Preservation Department – Item 4, LPC-23-05155

188 Spring Street – Sullivan-Thompson Historic District
Borough of Manhattan

188 SPRING STREET

STREET LEVEL FAÇADE ALTERATION AND REAR HORIZONTAL ENLARGEMENT OF EXISTING 4-STORY RESIDENCE. REPLACEMENT OF ALL WINDOWS AND DOORS.

PREVIOUSLY PROPOSED | FRONT FACADE

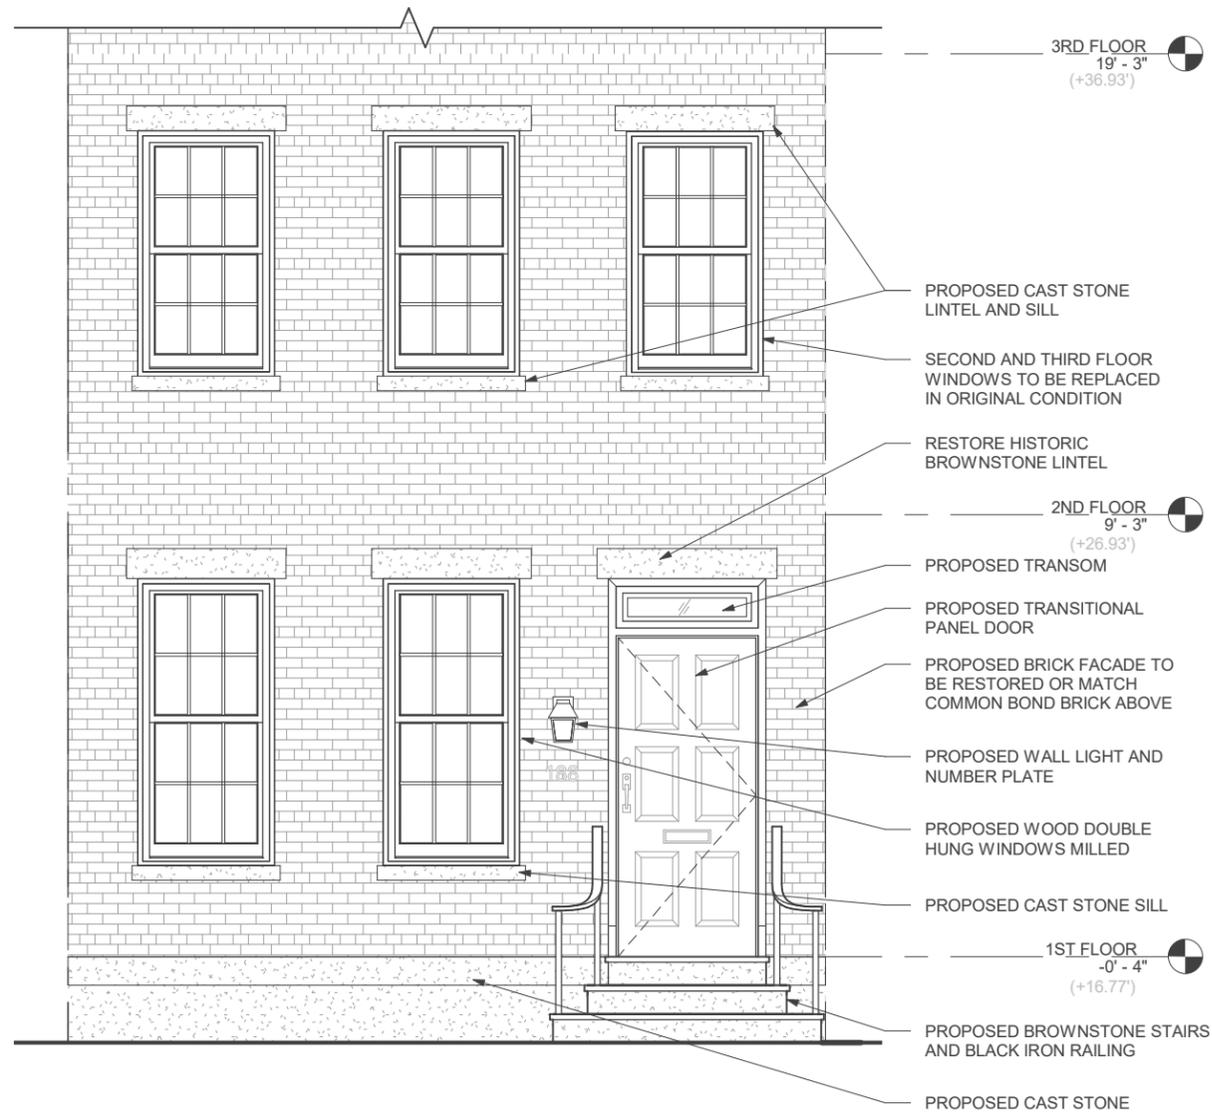
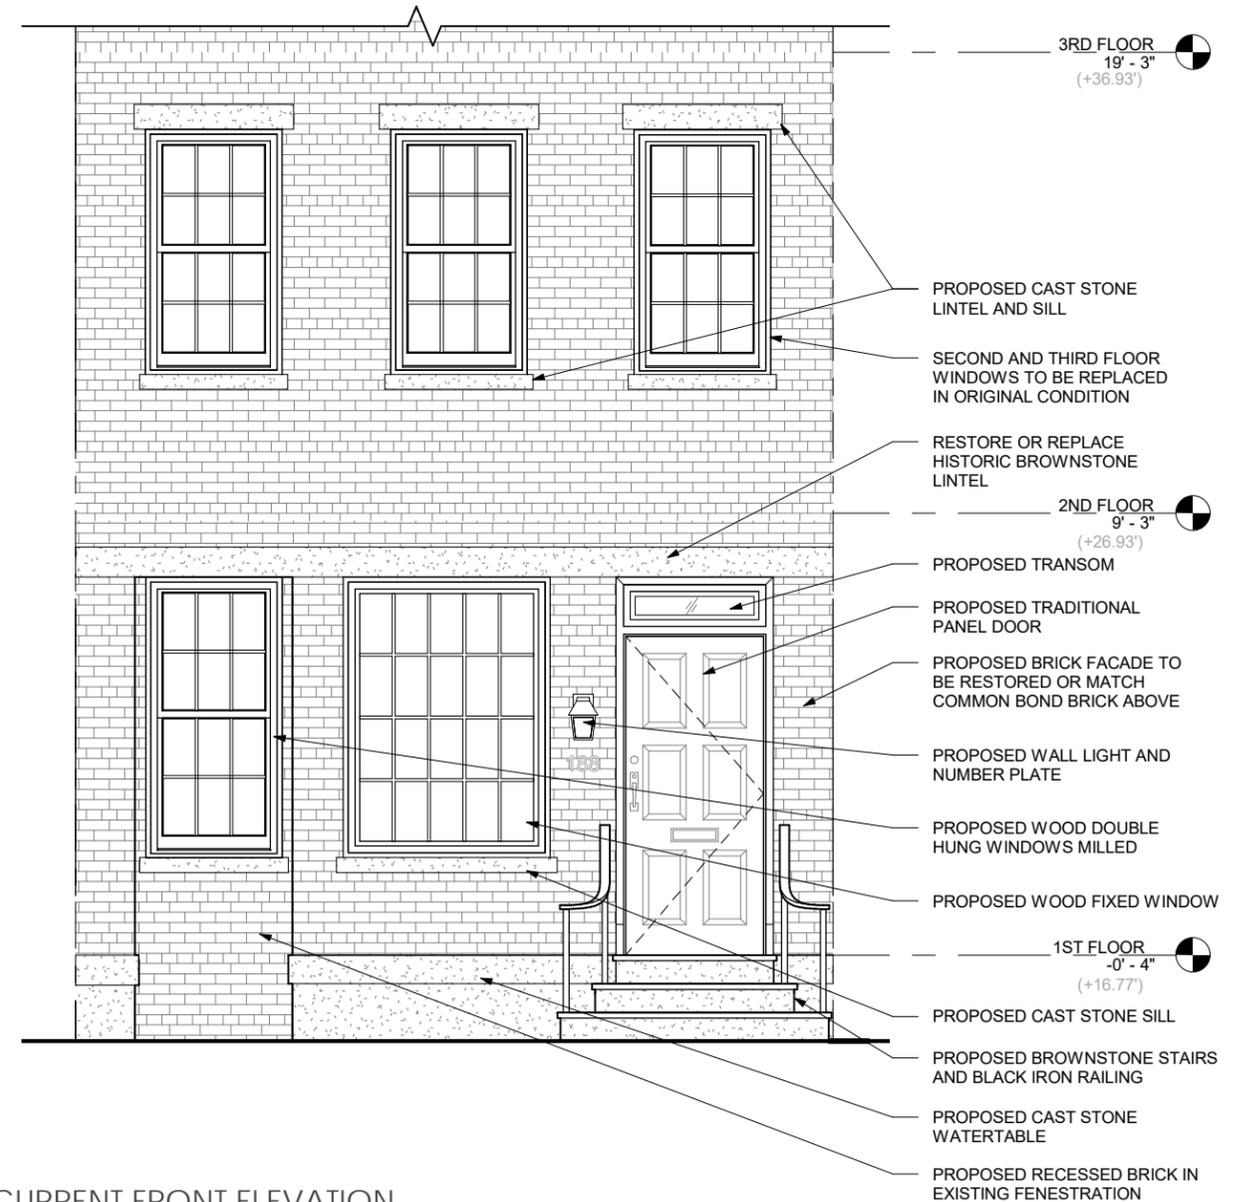
COMMENT: MAINTAIN HISTORIC TRIPARTITE CONFIGURATION.

COMMENT: RECALL HISTORIC HORSE PASS USING SAME OPENING AND REPLACING WITH INFILL THAT RELATES TO THE HISTORIC WINDOWS AND CURRENT USE.

RESPONSE: TRIPARTITE FENESTRATION IS MAINTAINED USING TRADITIONAL FEDERAL STYLE WINDOWS AND ENTRY DOOR WITHIN THE EXISTING OPENINGS.

RESPONSE: RECALLING HISTORIC HORSE PASS BY USING RECESSED BRICK DOWN TO THE GRADE WITHIN THE ORIGINAL OPENING LOCATION. A TRADITIONAL DOUBLE HUNG WINDOW IS SET WITHIN THE RECESSED BRICK TO REFLECT THE CURRENT RESIDENTIAL USE OF THE BUILDING.

PREVIOUSLY PROPOSED | REAR FACADE

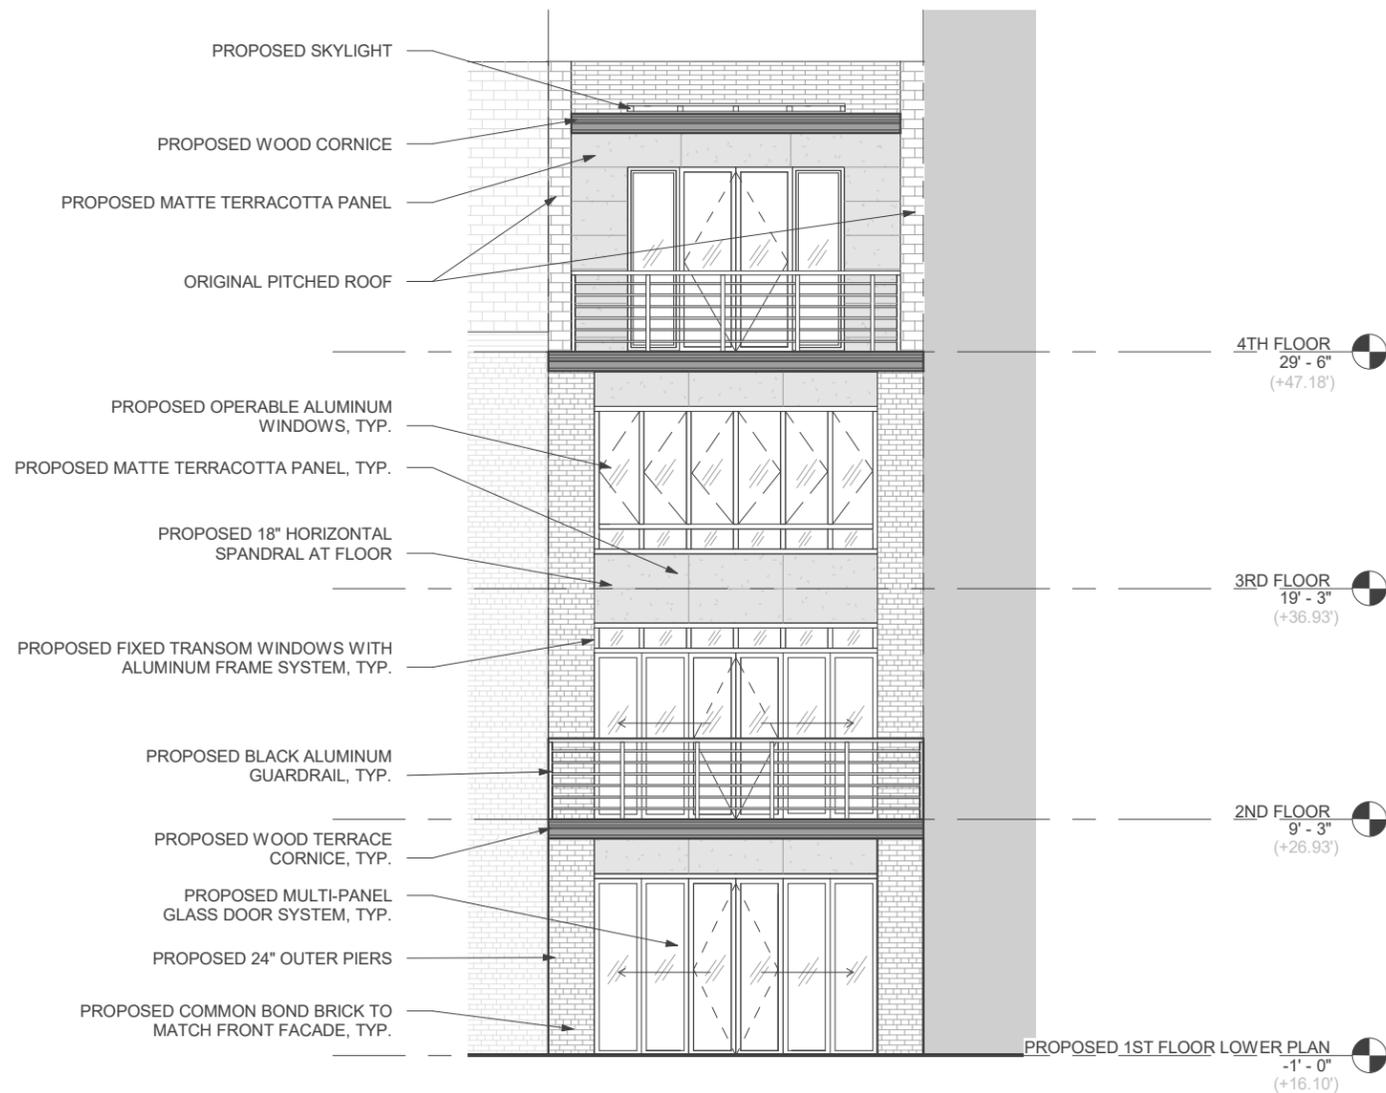
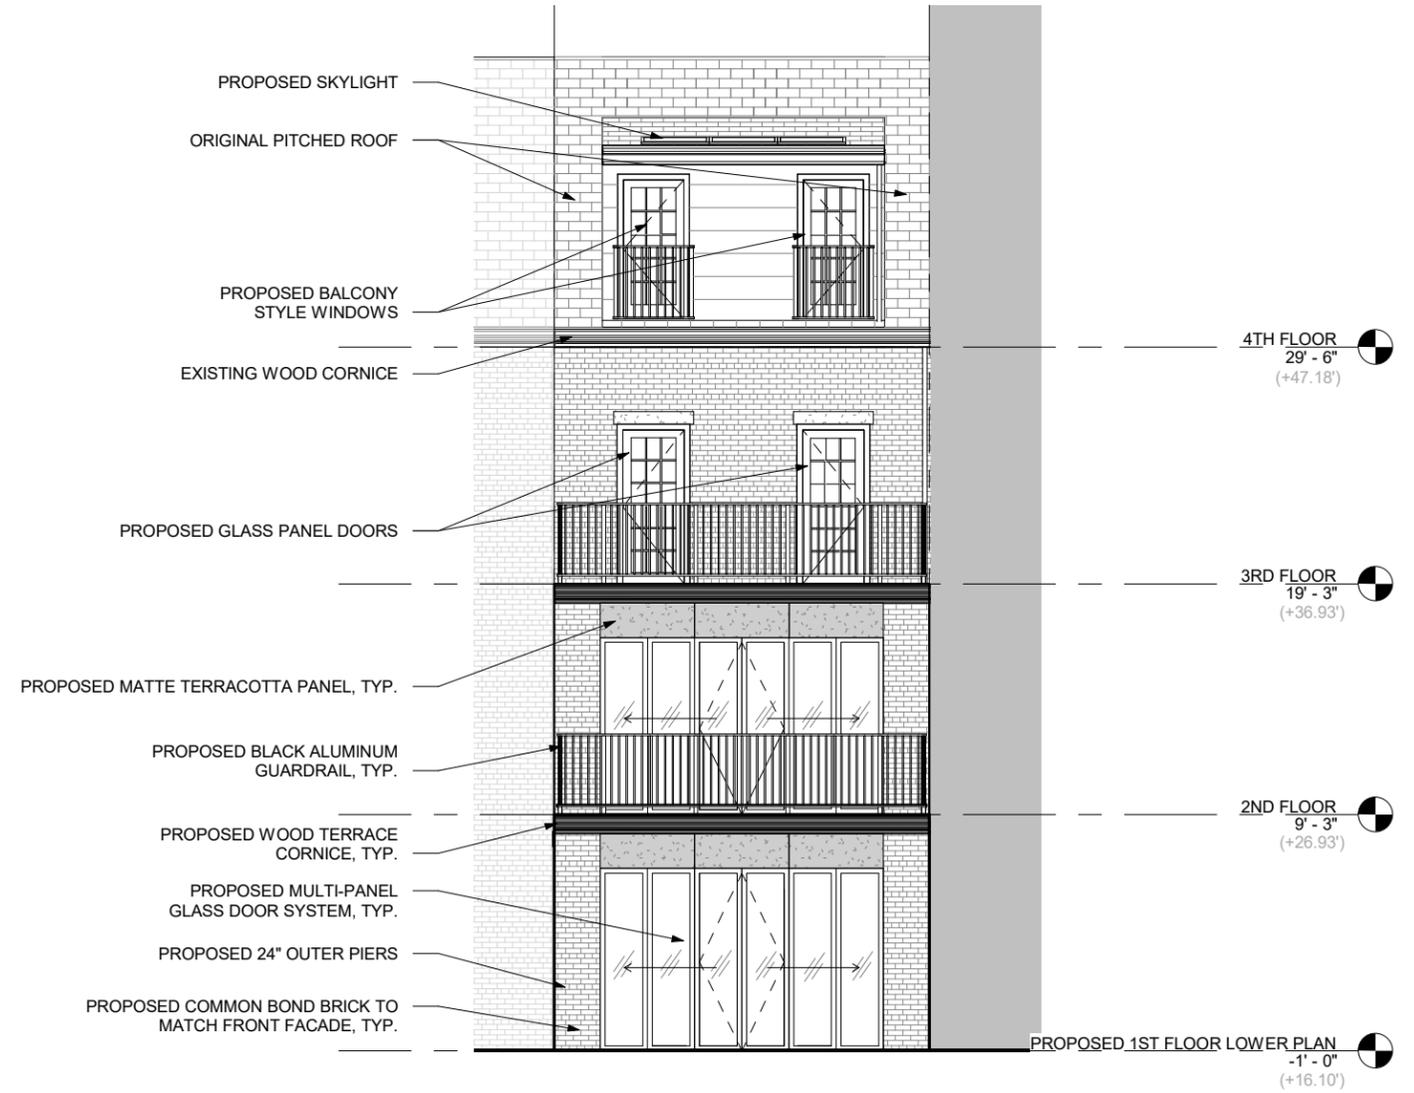
COMMENT: MORE RESTORATIVE APPROACH TO TOP LEVEL.

COMMENT: REDUCE HEIGHT AND WIDTH OF DORMER.

RESPONSE: REDUCED THE CONTEMPORARY GLAZING AND FINISHES HAVE BEEN REMOVED FROM THE TOP TWO LEVELS AND REPLACED WITH PUNCHED GLASS PANEL DOORS AND STONE LINTELS.

RESPONSE: THE DORMER HEIGHT HAS BEEN REDUCED TO KEEP THE CURRENT DORMER STYLE AND EXISTING PITCHED ROOF. THE WIDTH HAS BEEN KEPT EXISTING.

PREVIOUSLY PROPOSED | SECTION

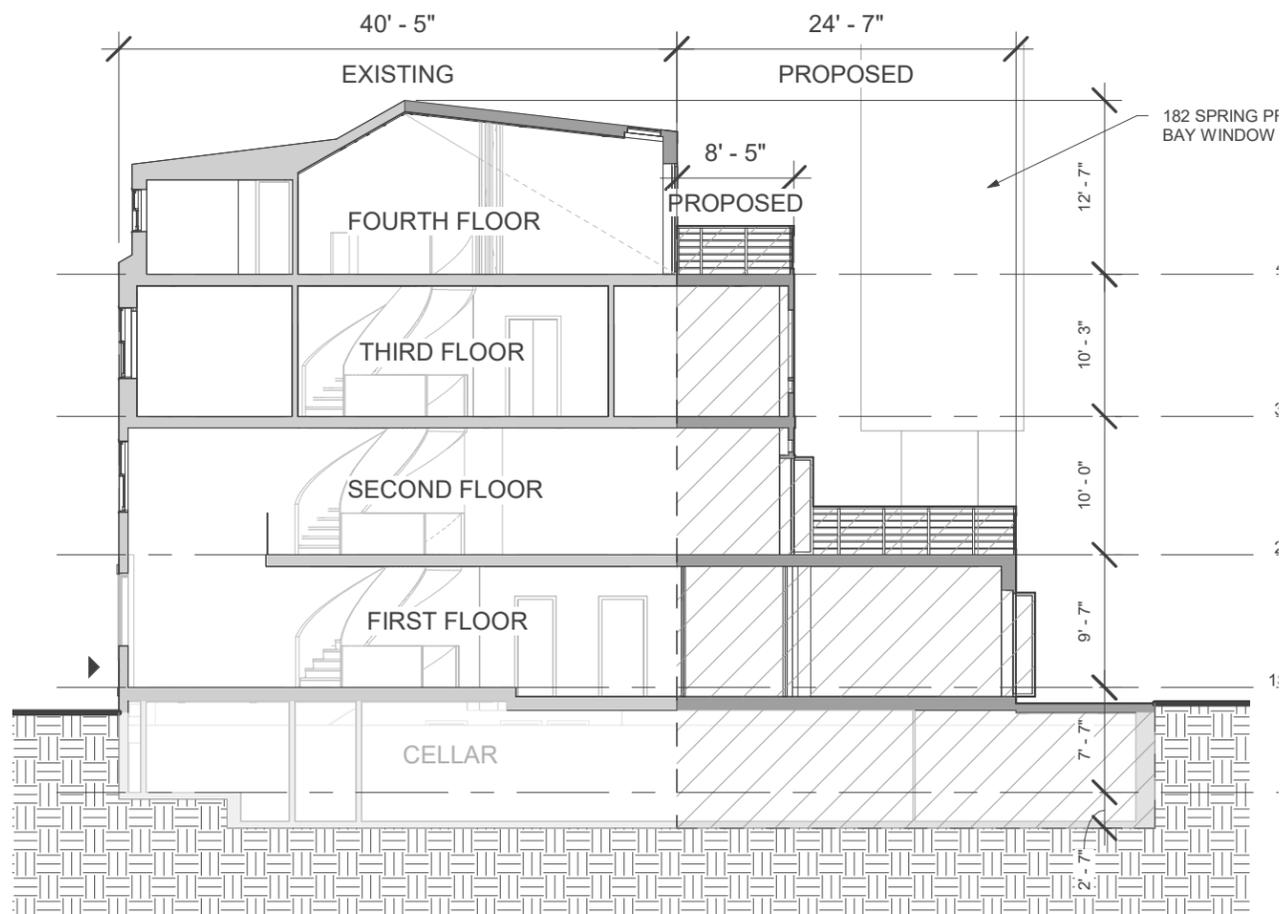
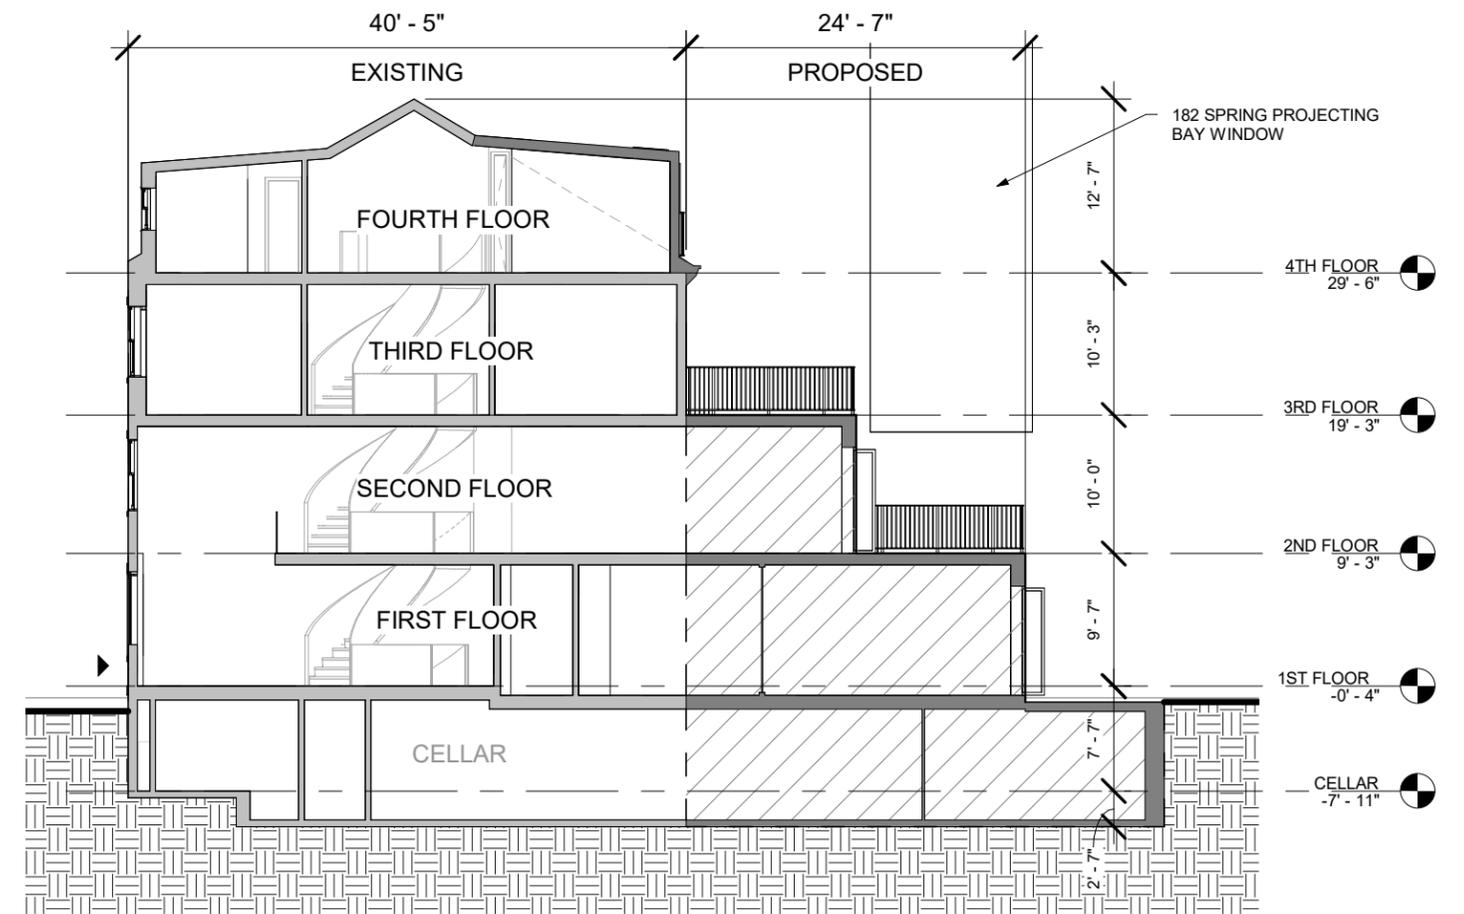
COMMENT: REDUCE REAR YARD ADDITION BY ONE FLOOR.
RESPONSE: REDUCED REAR ADDITION BY ONE FULL FLOOR.

COMMENT: DORMER SHOULD BE SET BACK FROM THE EDGE OF THE REAR FACADE.
RESPONSE: DORMER IS SET BACK FROM THE EDGE OF THE REAR FACADE, CONSISTENT WITH THE EXISTING CONDITIONS.
